100 Mount Street North Sydney

Project Approval MP08_0241

Environmental Assessment Report - Modification 4

December 2015

FIGURE 2 – NORTH ELEVATION AMENDMENTS

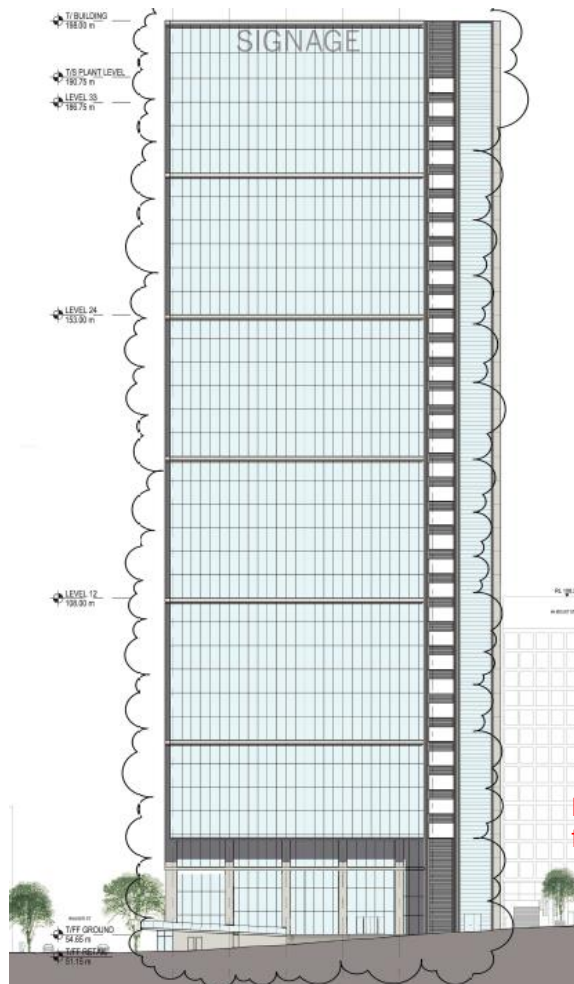
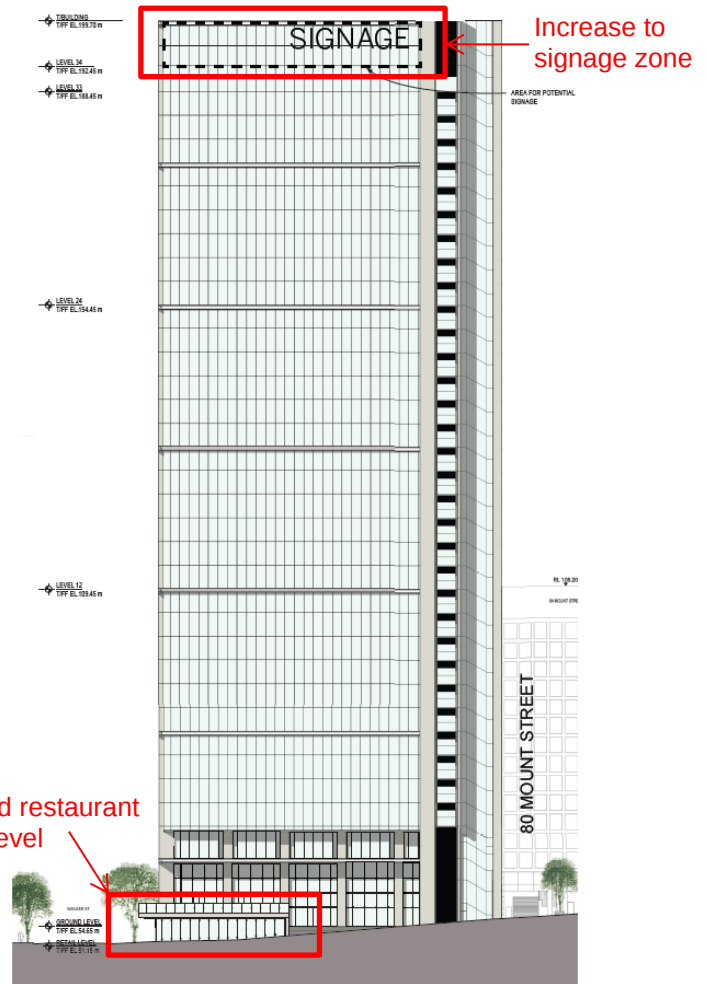
Proposed modification to the northern façade include:

- Minor increase to the overall height of the building;
- Increase to the signage zone at the top of the building; and
- Increase to the floor level of the ground floor restaurant, resulting in an increase in height to the outdoor dining area associated with the restaurant and greater exposure to the lower ground floor level tenancy.

FIGURE 3 – EAST ELEVATION AMENDMENTS

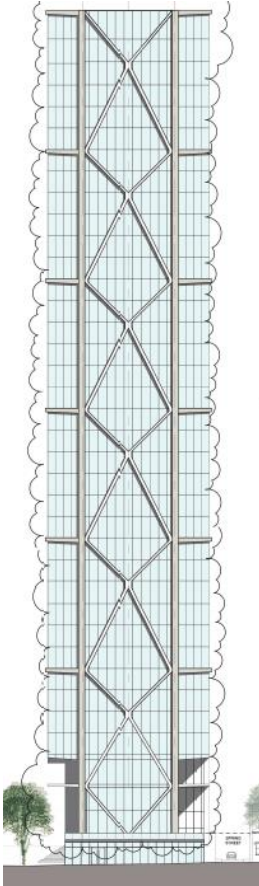
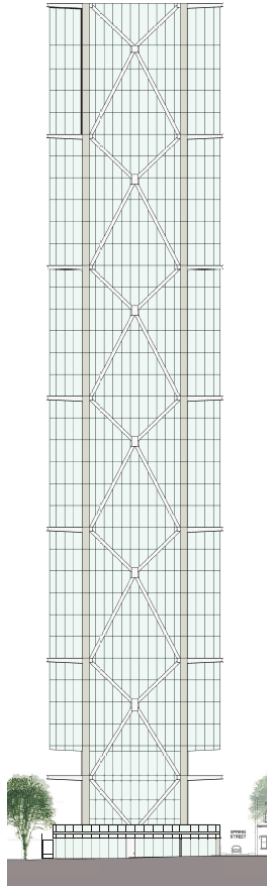
There are negligible amendments to the eastern elevation, being a minor increase to the overall height of the building.

FIGURE 4 – SOUTH ELEVATION AMENDMENTS

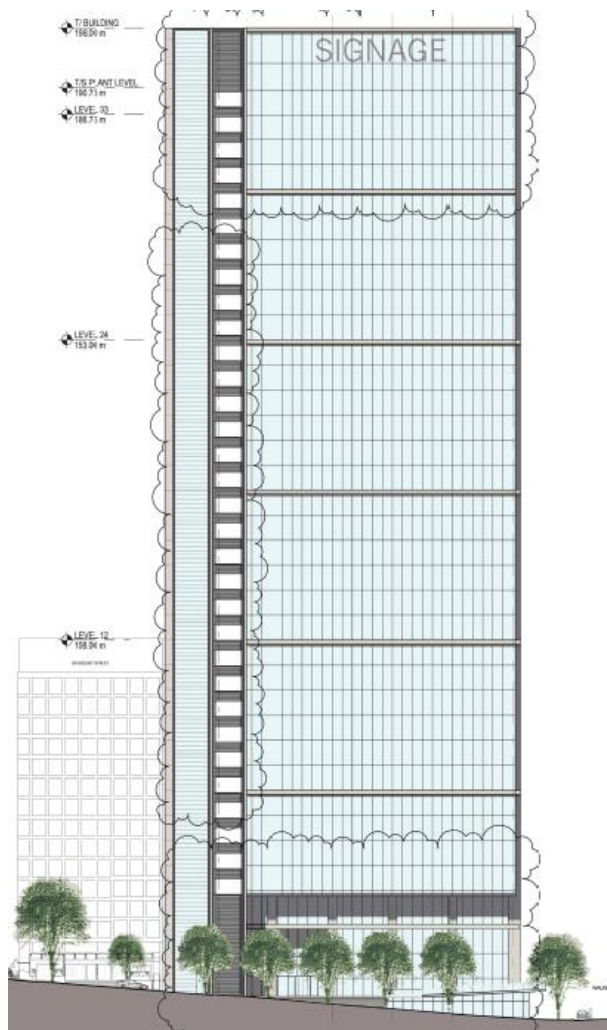
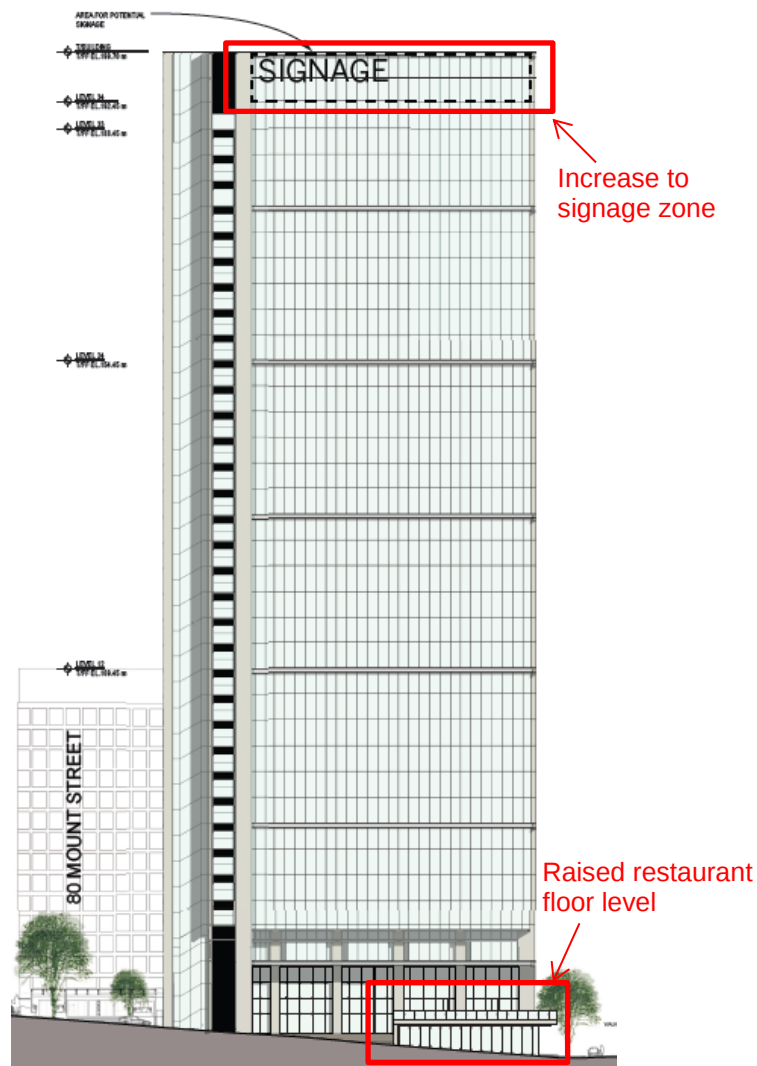
Proposed modification to the northern façade include:

- Minor increase to the overall height of the building;
- Increase to the signage zone at the top of the building; and
- Increase to the floor level of the ground floor restaurant, resulting in an increase in height to the outdoor dining area associated with the restaurant and greater exposure to the lower ground floor level tenancy.

FIGURE 5 – BASEMENT LEVEL 6 AMENDMENTS

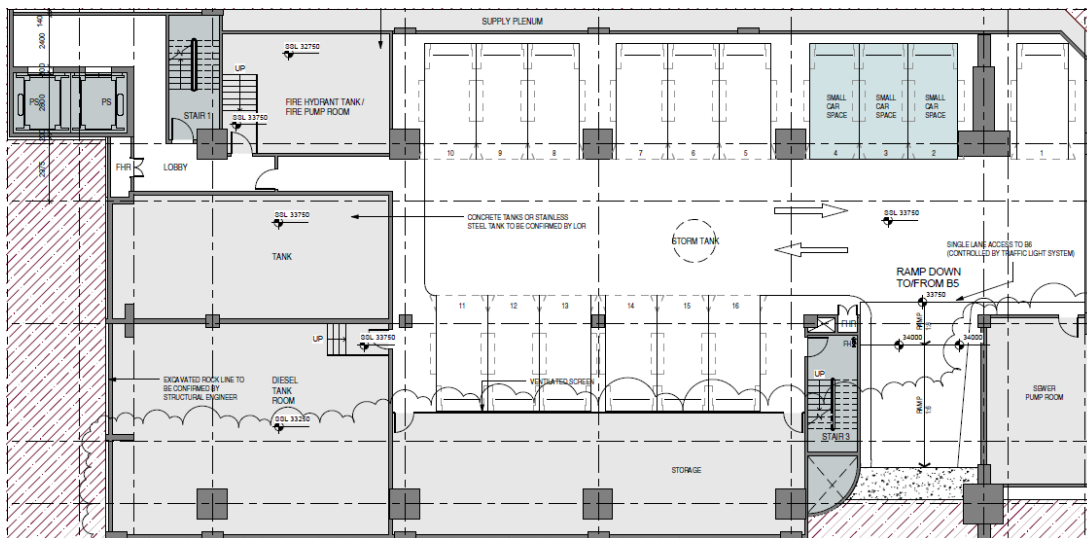
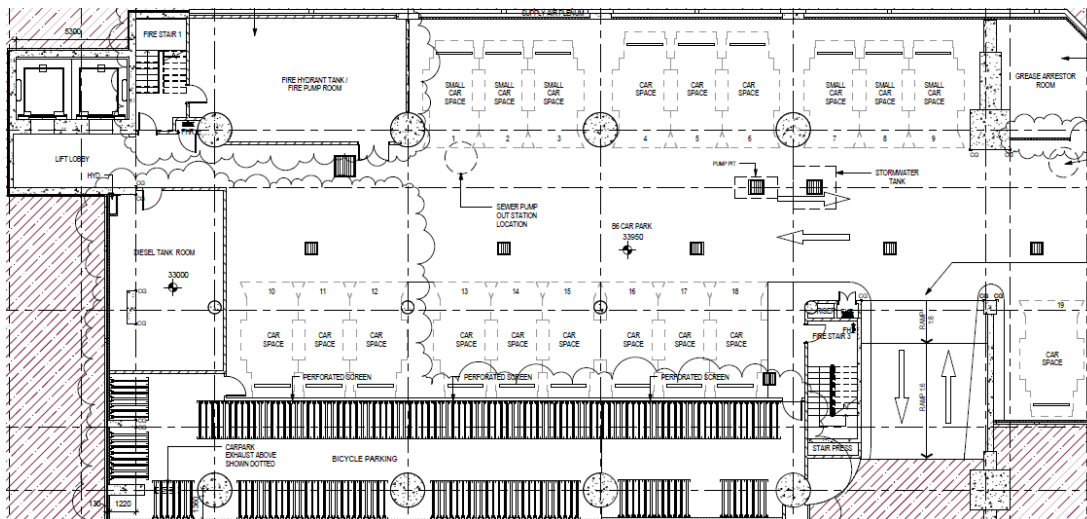
The following modifications are proposed for Basement Level 6:

- Rearrangement of car parking spaces and increase in quantity from 16 spaces (including 3 small car spaces) to 16 small car spaces.
- Relocation of diesel tank room, sewer pump out station and lifts.
- Deletion of storage area.
- Addition of grease arrestor room and bicycle parking facilities.

FIGURE 6 – BASEMENT LEVEL 5 AMENDMENTS

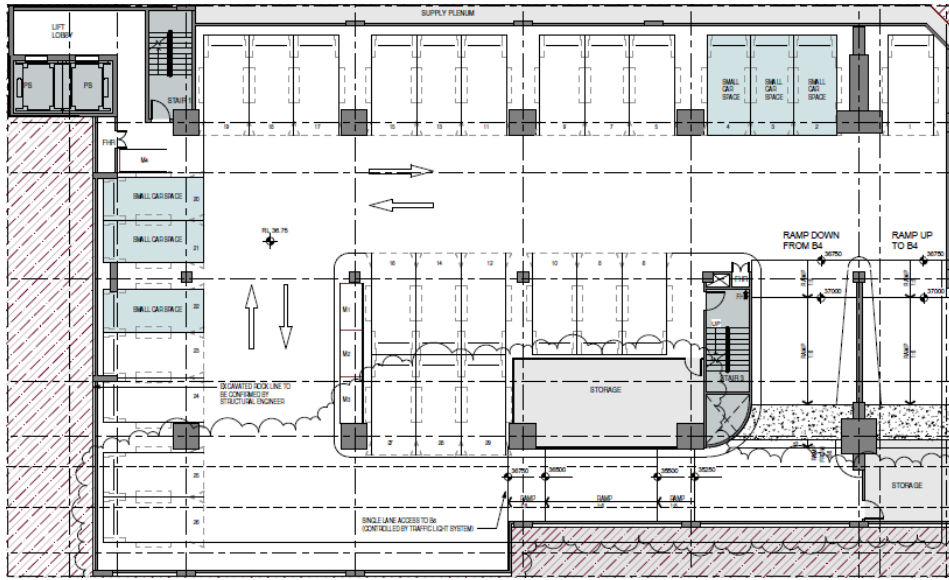
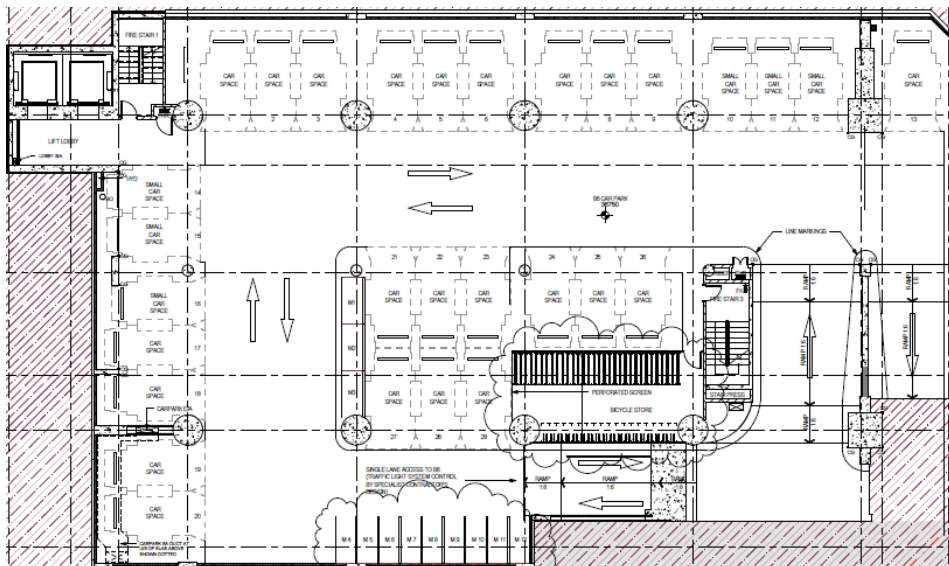
The following modifications are proposed for Basement Level 5:

- Addition of 9 motorcycle spaces.
- Replacement of storage room with bicycle storage facilities.
- Deletion of storage room in south-eastern corner of building.
- Reconfiguration of lifts.

FIGURE 7 – BASEMENT LEVEL 4 AMENDMENTS

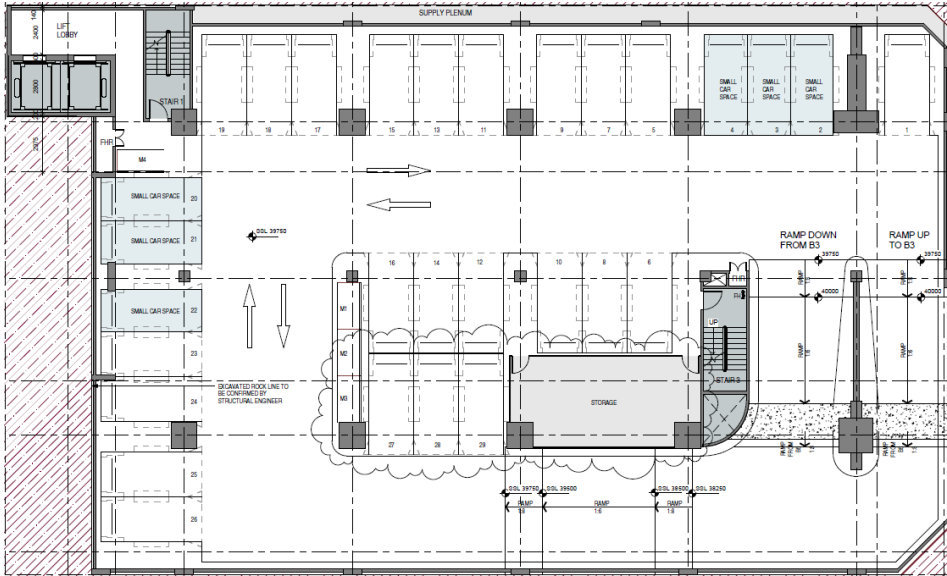
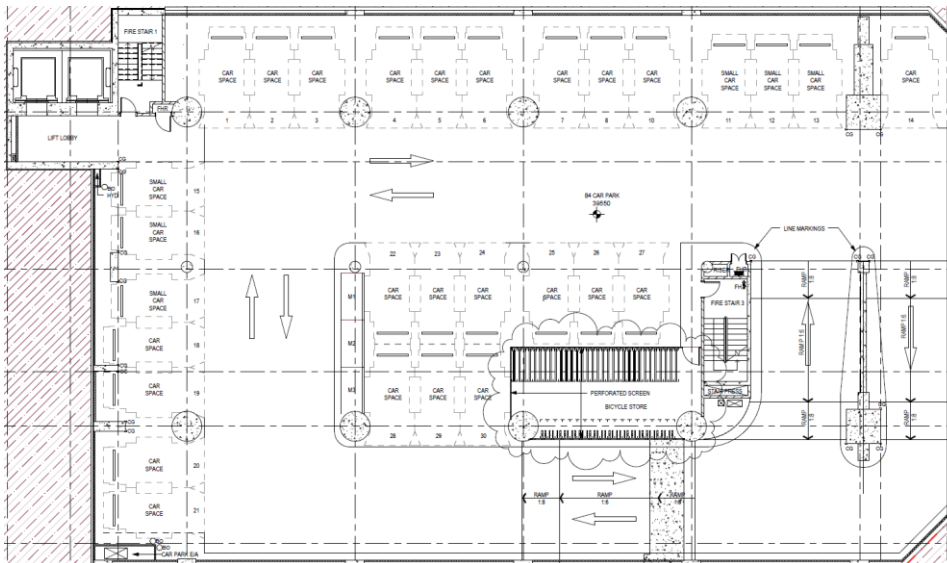
The following modifications are proposed for Basement Level 4:

- Replacement of storage room with bicycle storage facilities.
- Reconfiguration of lifts.
- Deletion of one motorcycle parking space.

FIGURE 8 – BASEMENT LEVEL 3 AMENDMENTS

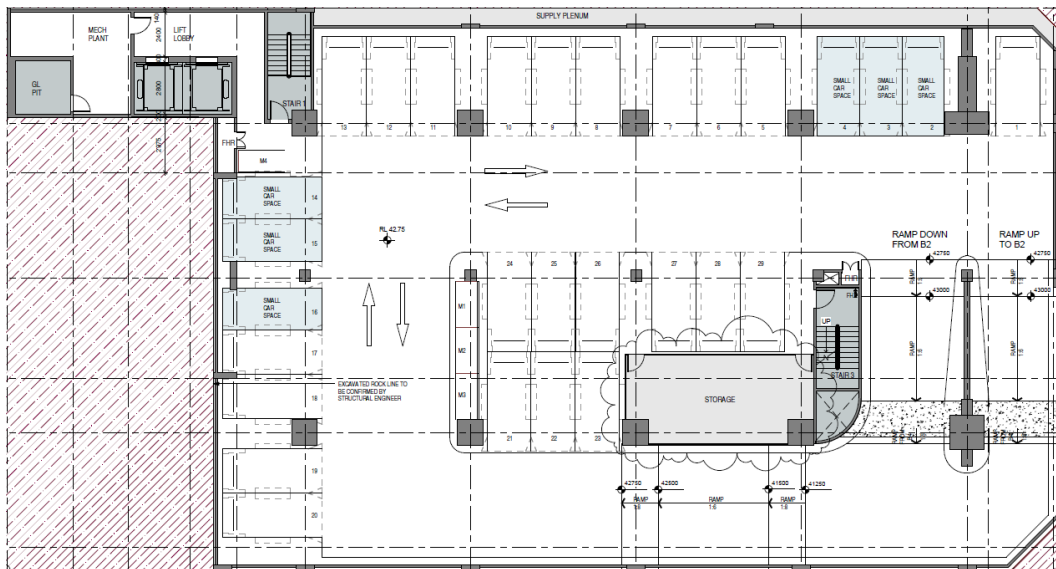
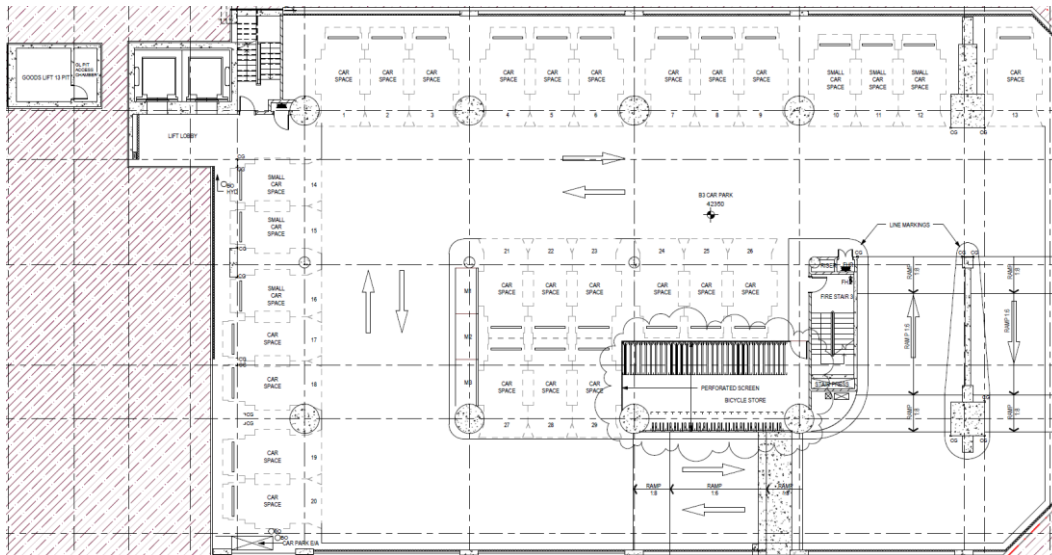
The following modifications are proposed for Basement Level 3:

- Replacement of storage room with bicycle storage facilities.
- Reconfiguration of lifts and goods lift pit.
- Deletion of one motorcycle parking space.
- Relocation of fire hose reel.

FIGURE 9 – BASEMENT LEVEL 2 AMENDMENTS

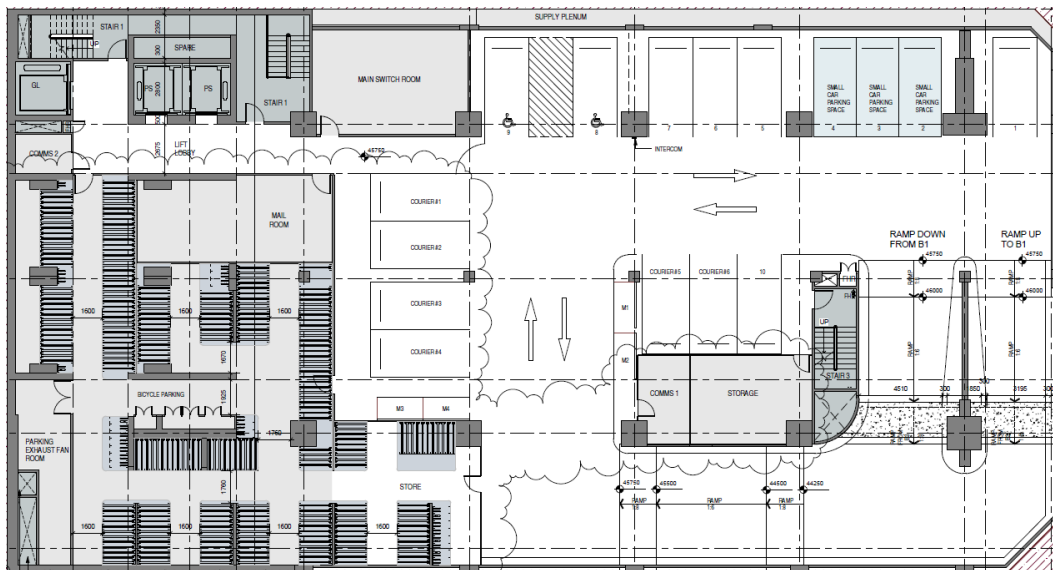
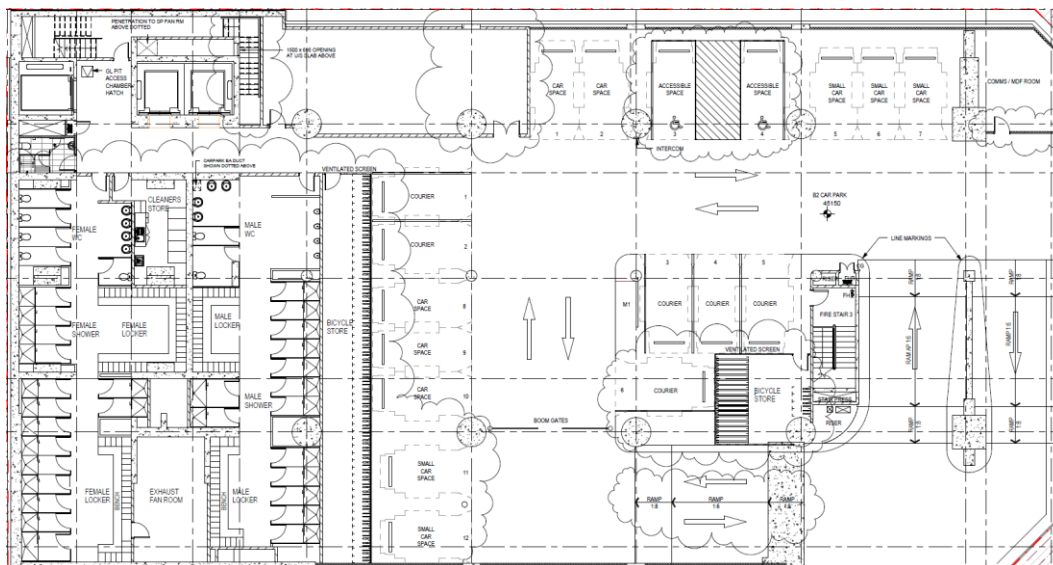
The following modifications are proposed for Basement Level 2:

- Reconfiguration of car parking, including an additional 4 spaces, and reconfiguration and reduction of bicycle storage to accommodate end of trip facilities which include showers, lockers and toilets.
- Relocation of communications room, exhaust fan room and fire hose reel.
- Addition of boom gates.
- Deletion of mail and storage rooms.
- Reconfiguration of lifts and goods lift pit.
- Reduction of three motorcycle parking spaces.

FIGURE 10 – BASEMENT LEVEL 1 AMENDMENTS

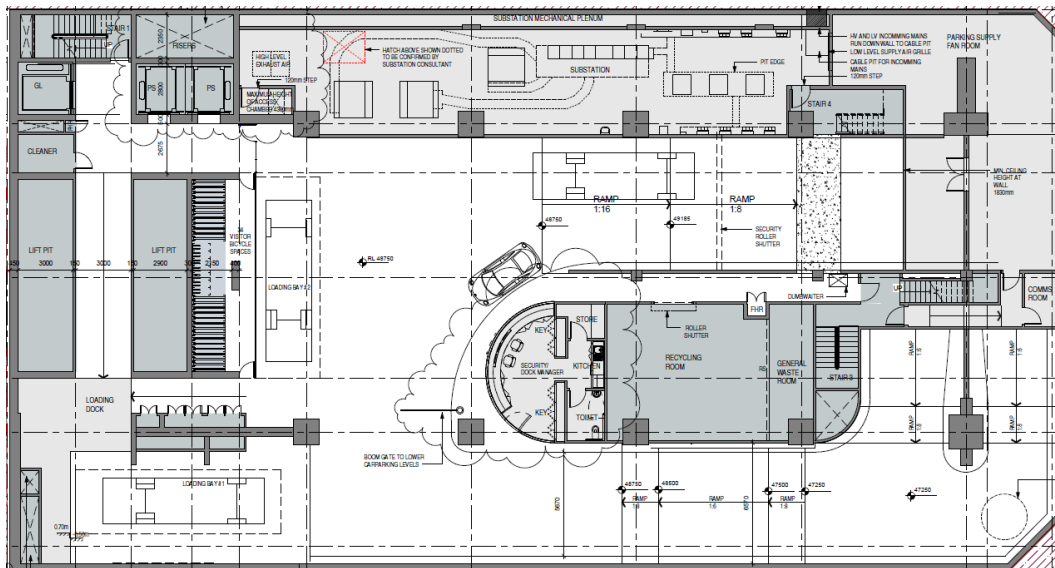
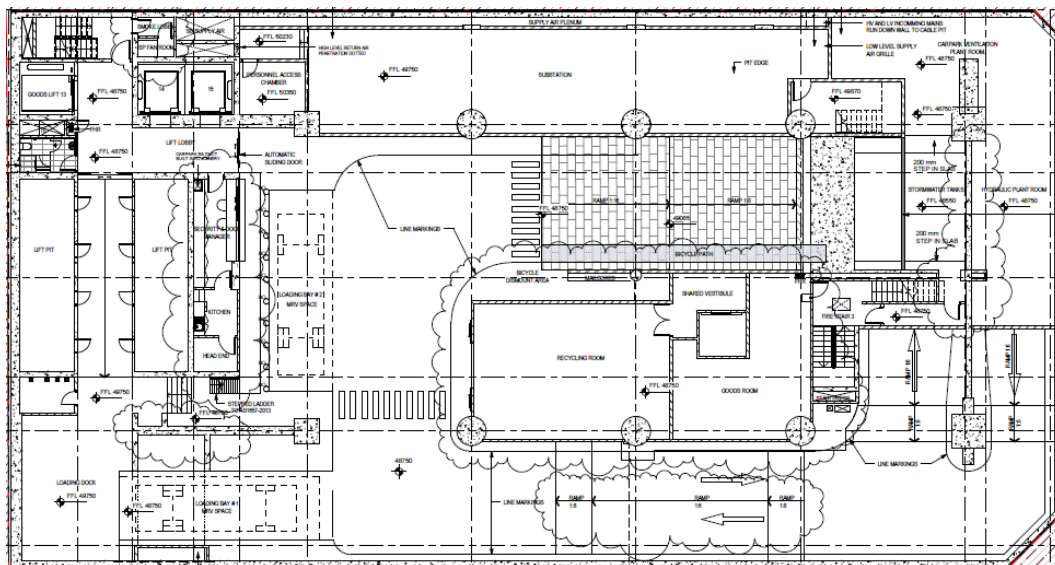
The following modifications are proposed for Basement Level 1:

- Relocation of security and dock manager office.
- Deletion of bicycle storage and boom gate.
- Reconfiguration of recycling room and creation of goods room.
- Enlargement of loading dock.
- Replacement of cleaner closet with bathroom.
